December 30, 2024

**Chair Gregory Rondeau
Town of Franklin Planning Board
355 East Central Street
Franklin, Massachusetts 02038**

**RE: 55 Constitution Boulevard
Site Plan Review
Peer Review Response**

Sheet Number
C121

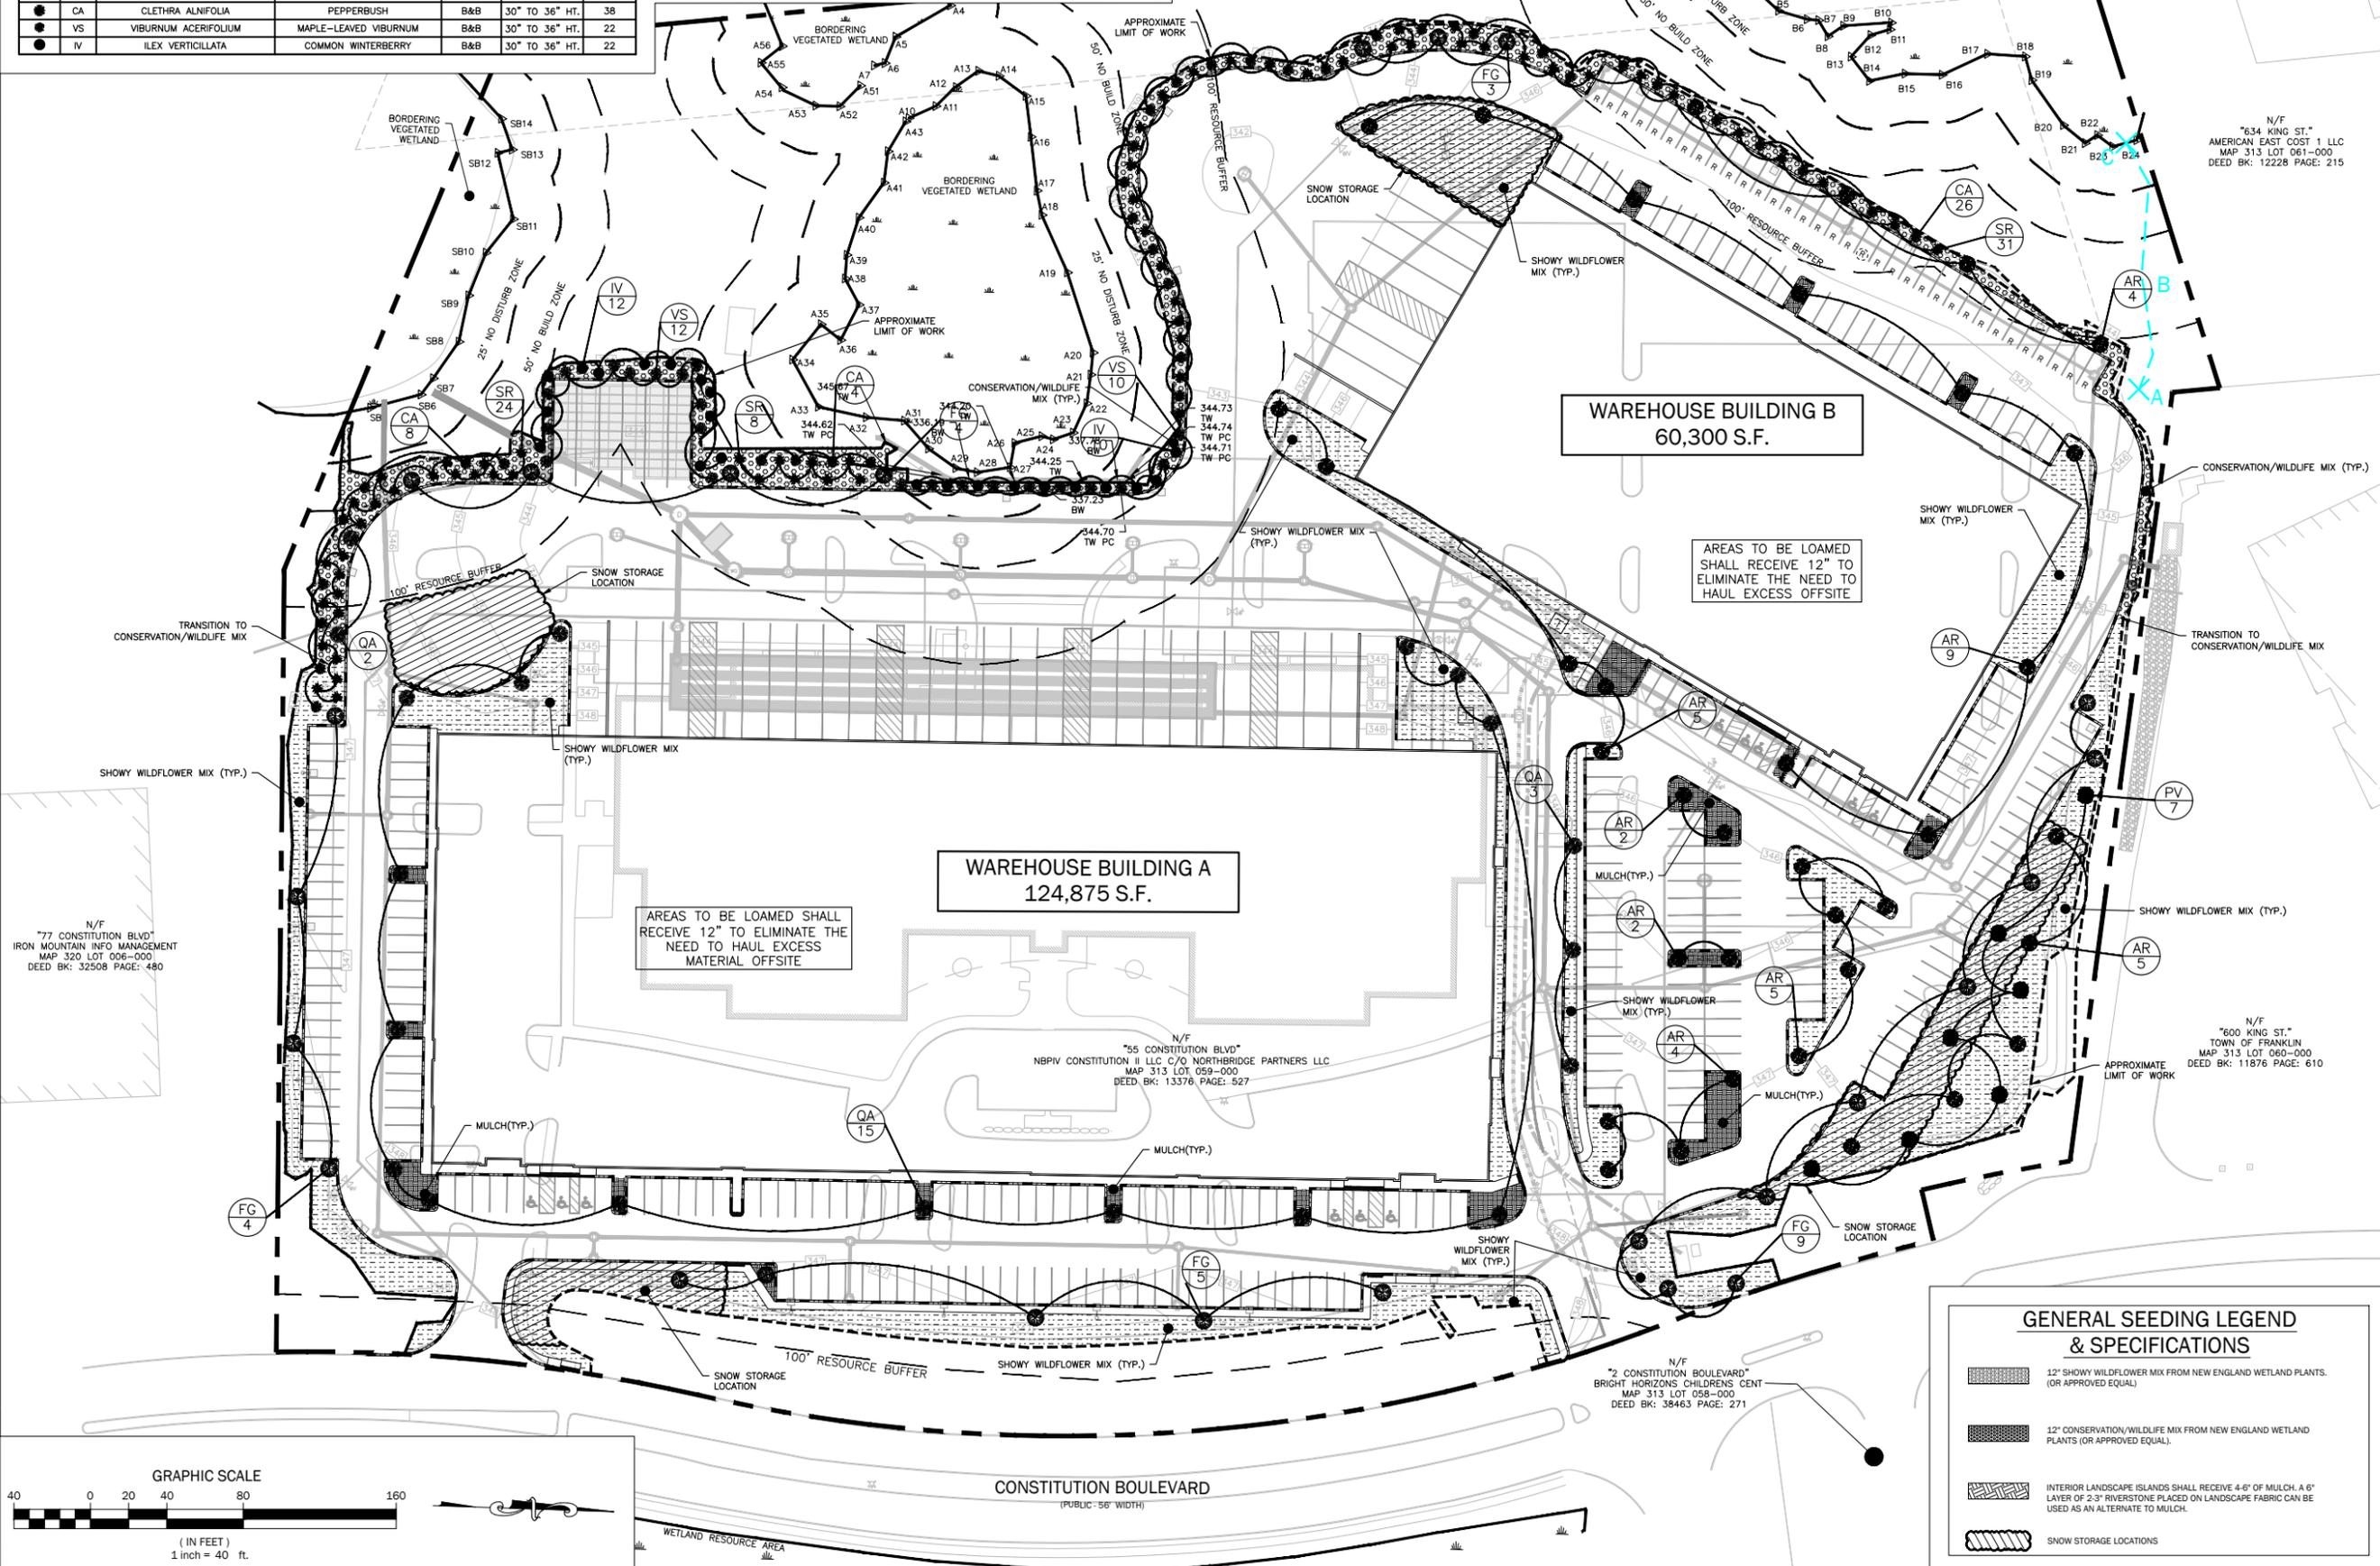
Provide information on seed mixes; use of native seeding is encouraged especially in areas which are not required to be a fine lawn and in proximity to wetland resource areas.

Our office has revised Sheet C121, Landscape Plan, to include seed mixes such as a New England Showy Wildflower Mix and a New England Conservation/Wildlife Mix, and the locations of these seed mixes have been depicted on the plan. Additional plantings have been added along the pervious areas within the resource areas to improve the vegetated buffer zones. Specifications for each of the two seed mixes being used for stabilization of the site have been provided. See Attachment D for the specifications.
